**ENVIRONMENTAL**

**IMPACT REPORT**

**UPTOWN NEWPORT**

**SCH NO. 2010051094**

## Phase 1 Master Site Plan

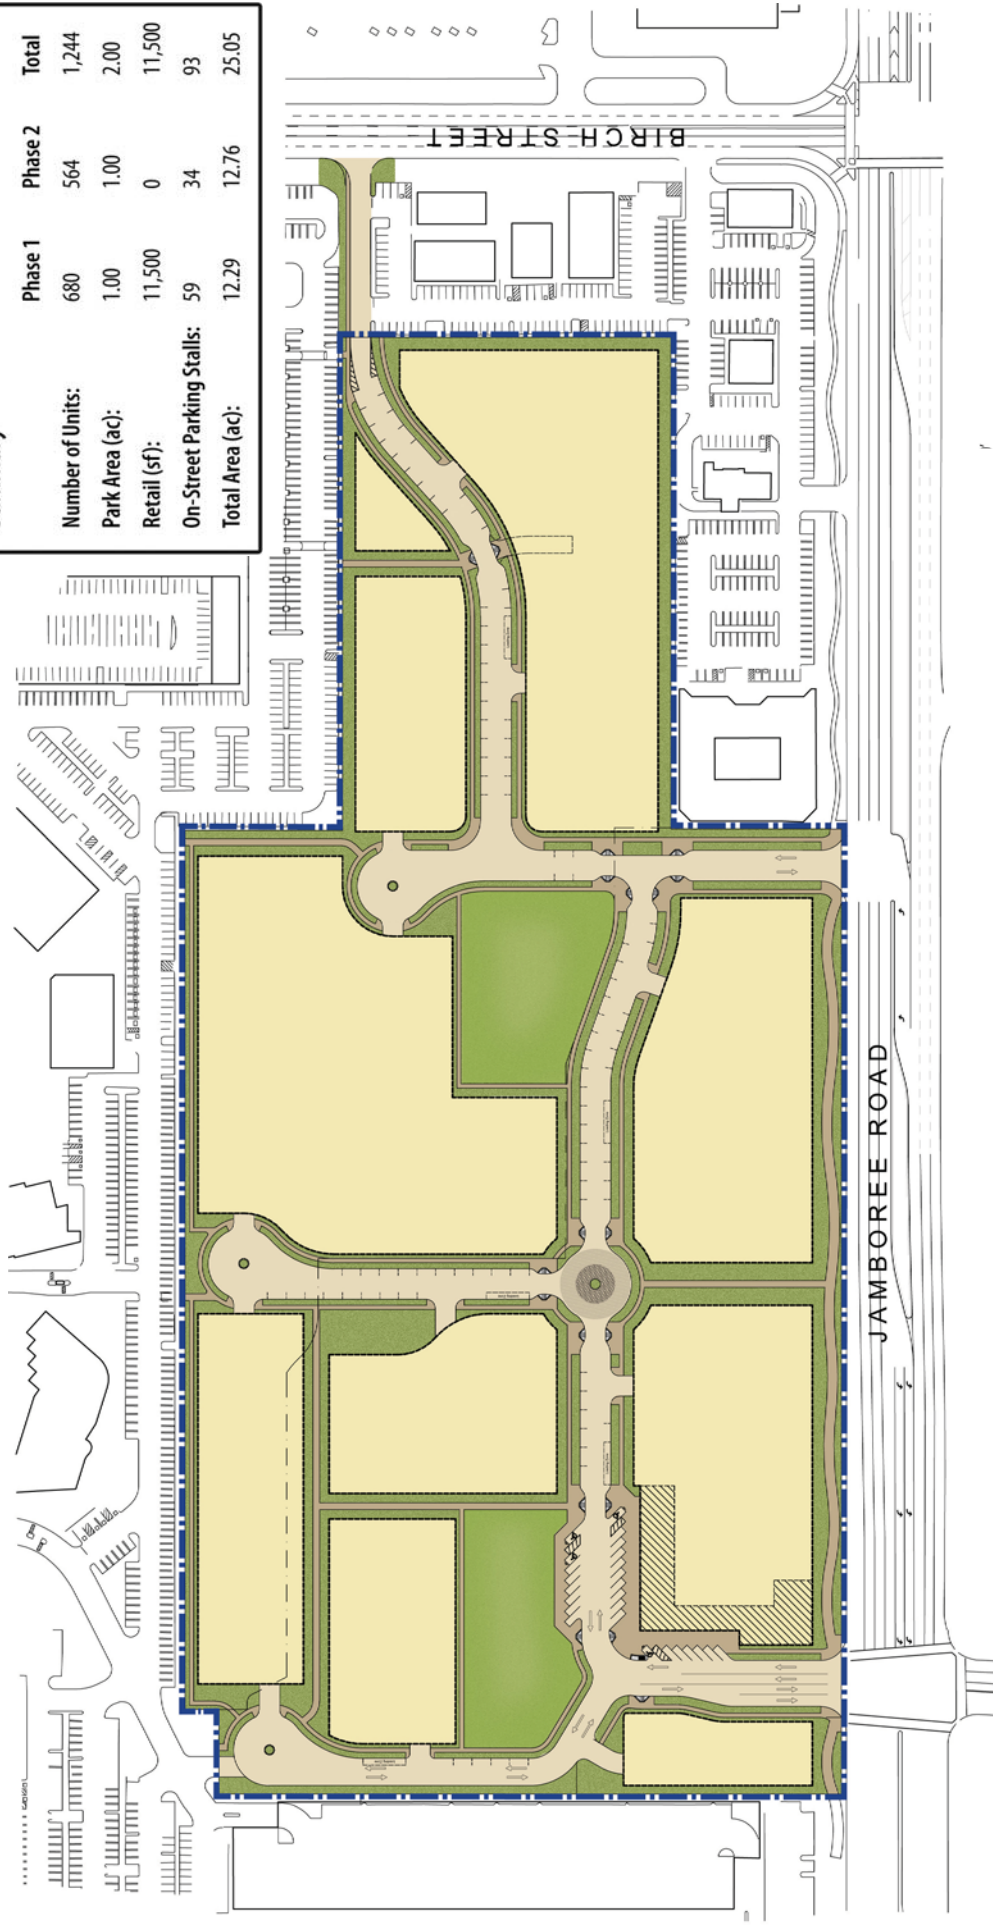
The Master Site Plan for the Uptown Newport has been revised to address comments and concerns raised by the City of Newport Beach Planning Commission and general public during the Planning Commission study session and public hearings. Phase 1 of the revised plan is shown as Figure 3-6a, *Phase 1 Master Site Plan*, and the full buildout conditions for the project are shown in Figure 3-6b, *Master Site Plan*. Primary revisions to the site plan include:

## Storm Drainage Concept: Phase 1 and Phase 2

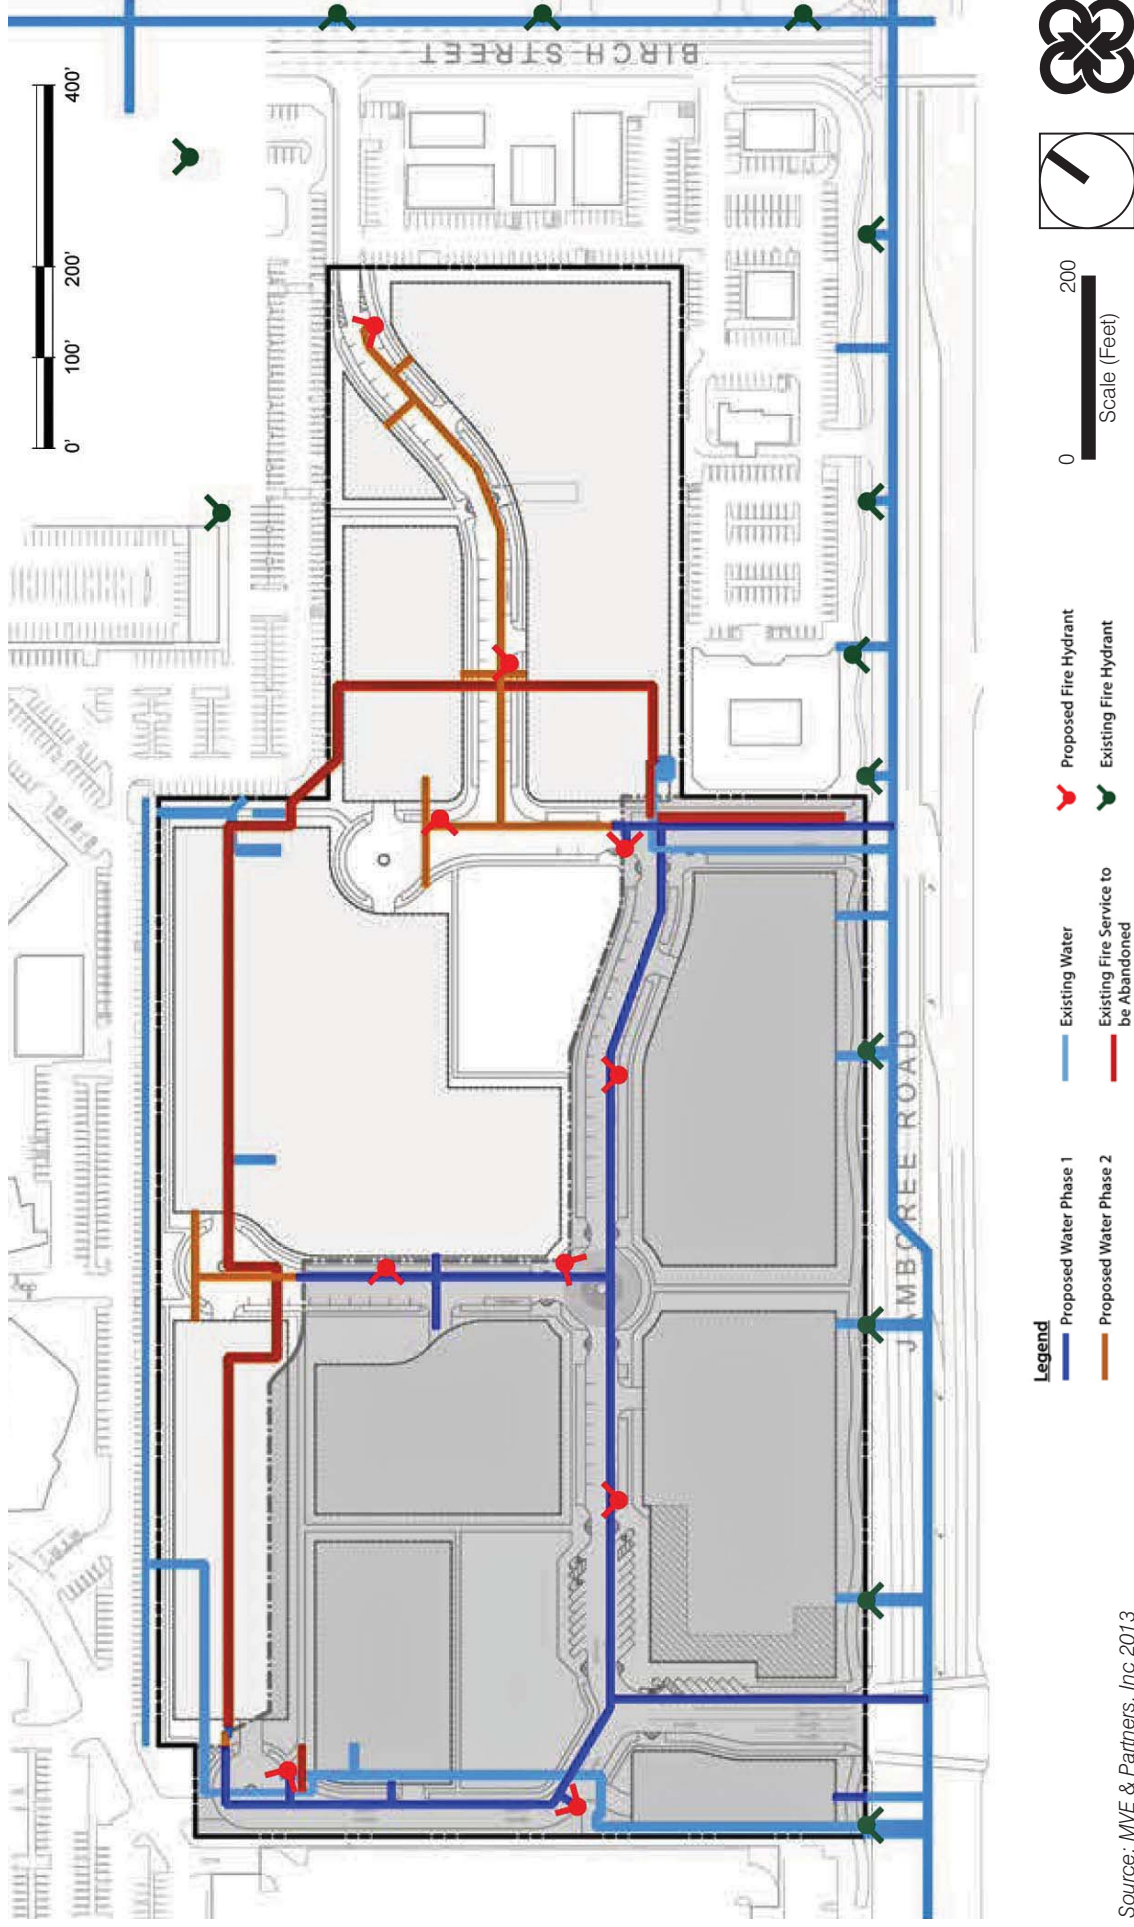
- Figure 3-10, *Storm Drainage Concept: Phase 1 and Phase 2*. This figure was modified to reflect the minor modifications that were made to the site plan and internal circulation plan.

*The Planning Center | DC&E • Figure 5.8-4*

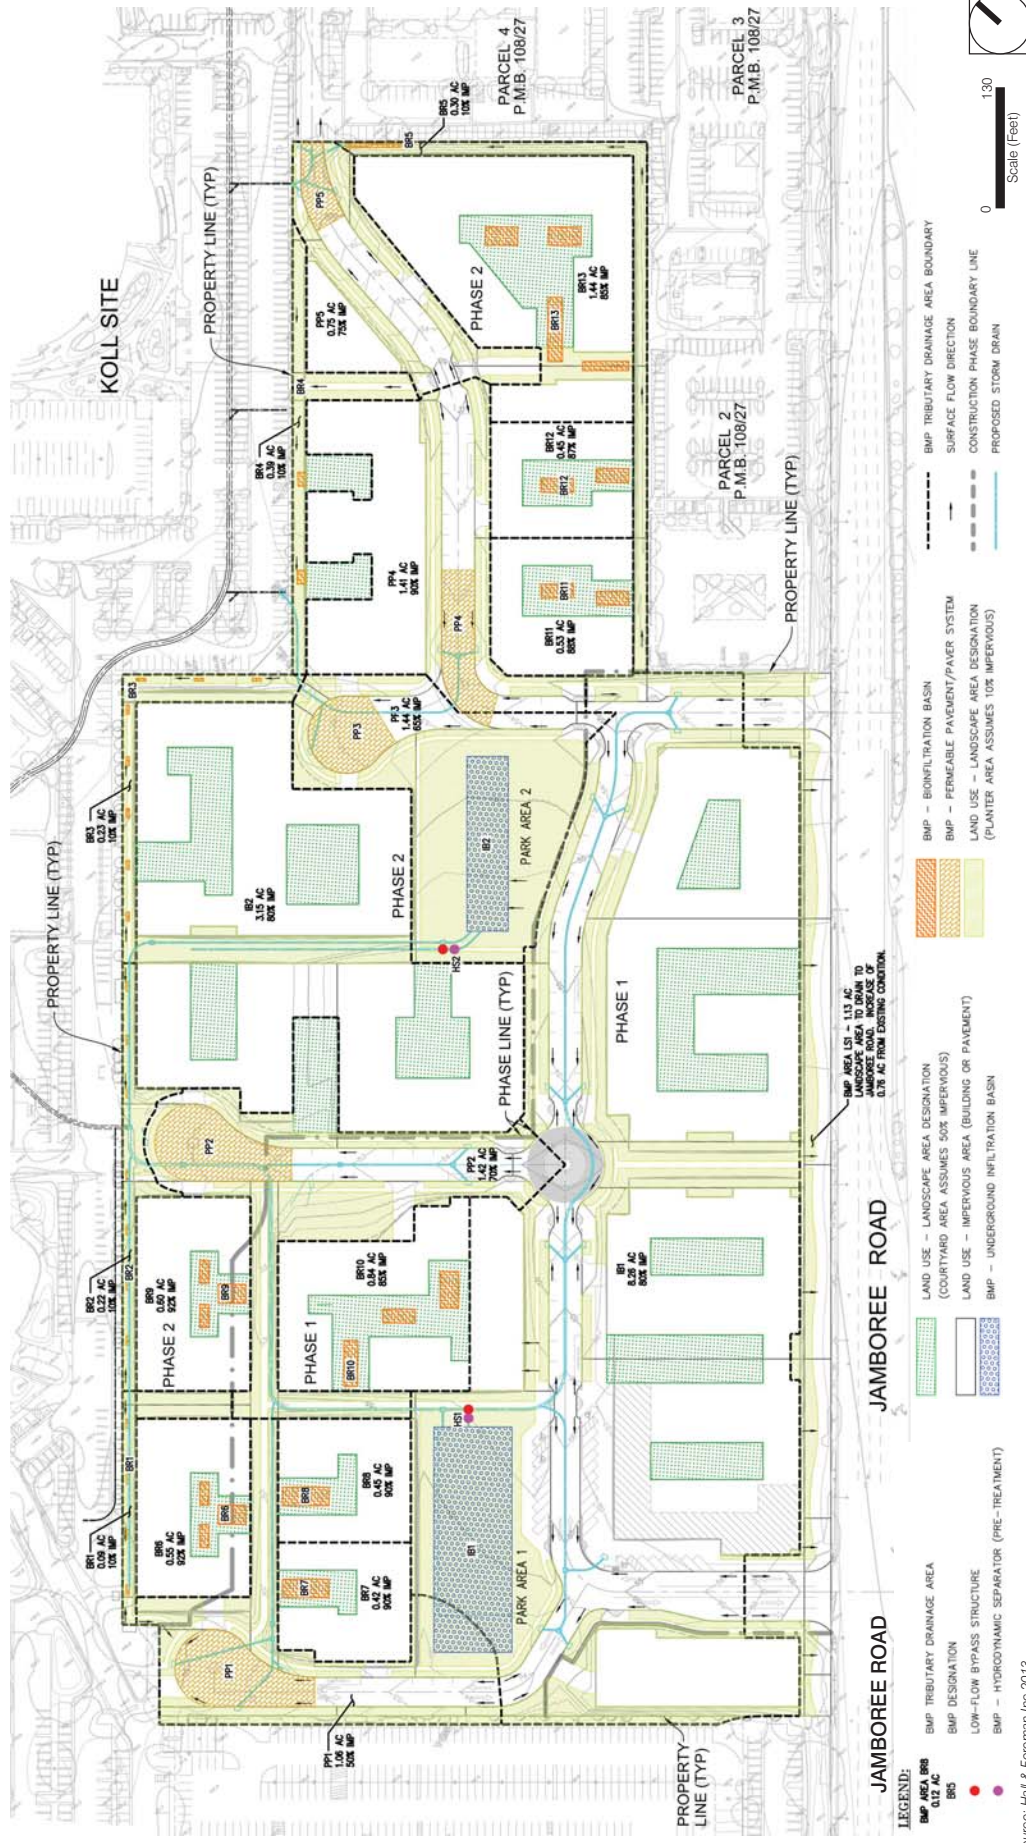
- Figure 5.8-4, *Phase 1 Storm Drain Concept*. This figure was modified to reflect the minor modifications that were made to the site plan and internal circulation plan.

# Cumulative Projects and SAUSD School Attendance Area Boundaries

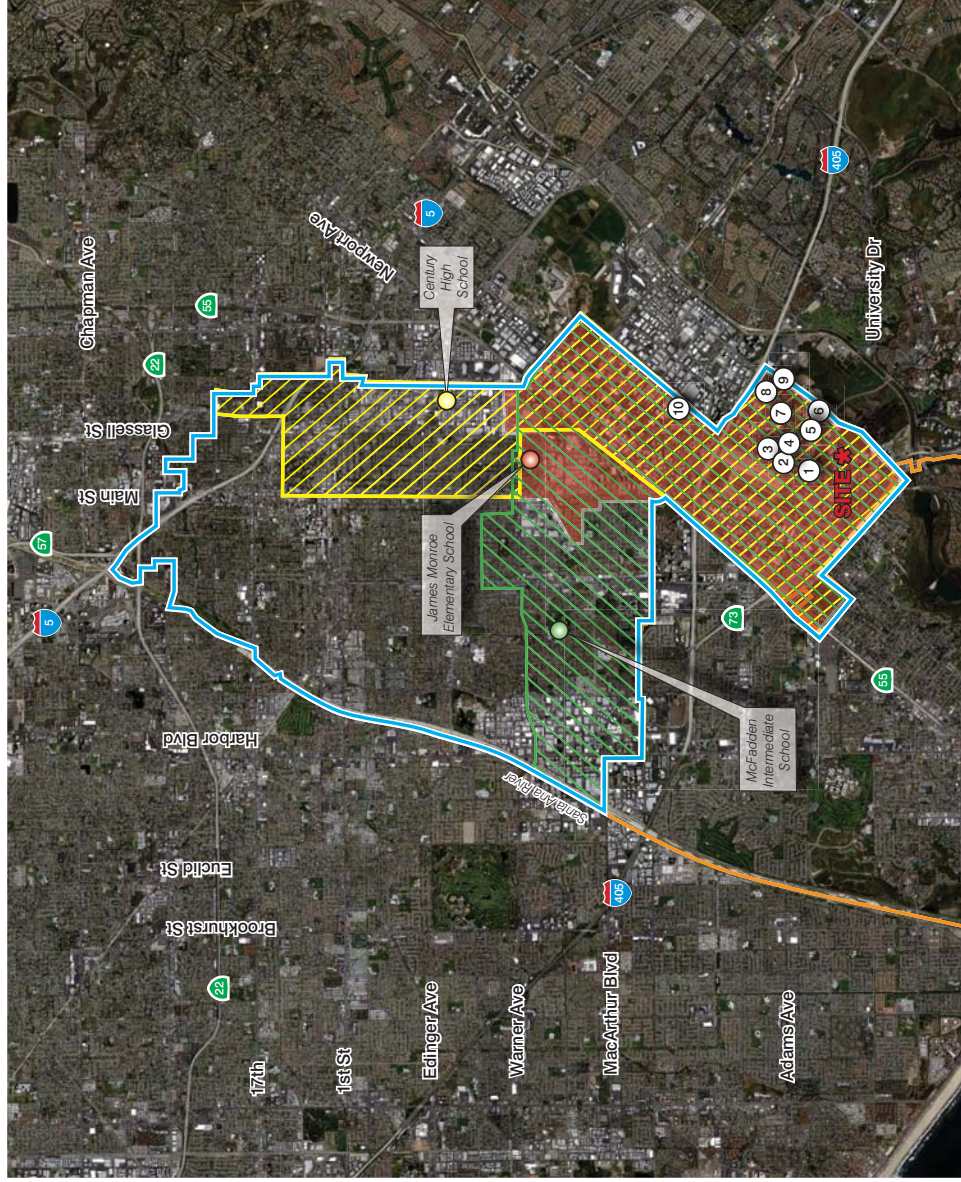
Section 5.12.3.4 says, “No cumulative projects including residential use, which would therefore generate students, were identified within SAUSD boundaries.” This is not correct. Table 4-2, *Cumulative Projects*, lists six residential projects within SAUSD boundaries, including #6 Koll Center, #12 Central Park, #15 The Lofts, #18 Plaza II and IV, #19 Carlyle, and #28 Martin Street Residential. Each one of those projects will impact SAUSD enrollment and should be considered cumulatively as part of this DEIR.

In addition, Table 4-2 is missing a planned residential project within the vicinity of the Uptown Newport Project. The proposed Irvine Technology Center is located at the northeast corner of Jamboree Road and Campus Drive. The project includes the development of up to 1,800 single-family attached residential units and up to 17,000 square feet of retail and commercial uses.

Table 5.12-11, *Student Generation by Cumulative Projects*, does not analyze the cumulative impacts to SAUSD. As previously mentioned, the Cumulative Impacts section does not recognize the six residential projects within SAUSD referenced in Table 4-2. These cumulative projects include #6 Koll Center, #12 Central Park, #15 The Lofts, #18 Plaza II and IV, #19 Carlyle, and #28 Martin Street Residential. Table 5.12-11 also does not include the Irvine Technology Center, a planned residential and commercial project located at the corner of Jamboree Road and Campus Drive within SAUSD boundaries.

Student generation within SAUSD was calculated using the IUSD generation rates outlined in Table 5.12-9, *Student Generation Rates for Proposed Project*, similar to the proposed project. The locations of the cumulative projects within SAUSD's boundary listed in Table 4-2 are shown in Figure 5.12-3, *Cumulative Projects and SAUSD School Attendance Area Boundaries*. As shown below in Table 5.12-11, cumulative projects would generate approximately 269 students in SAUSD. As shown in Table 5.12-12, *SAUSD School Capacity With Cumulative Projects*, with development of the proposed project and cumulative projects, all three SAUSD schools (James Monroe Elementary School, McFadden Intermediate School, and Century High School) would all be over capacity. It should be noted, however, that the capacity shown in Table 5.12-12 for each school does not include portable classrooms, only permanent classroom capacity. As with the proposed project, each cumulative project would be required to pay school impact fees pursuant to SB 50; payment of such fees is considered full mitigation for impacts to public school facilities. The increase in school service demand due to the proposed project would, therefore, not combine with future demand to result in cumulatively considerable impacts on SAUSD.
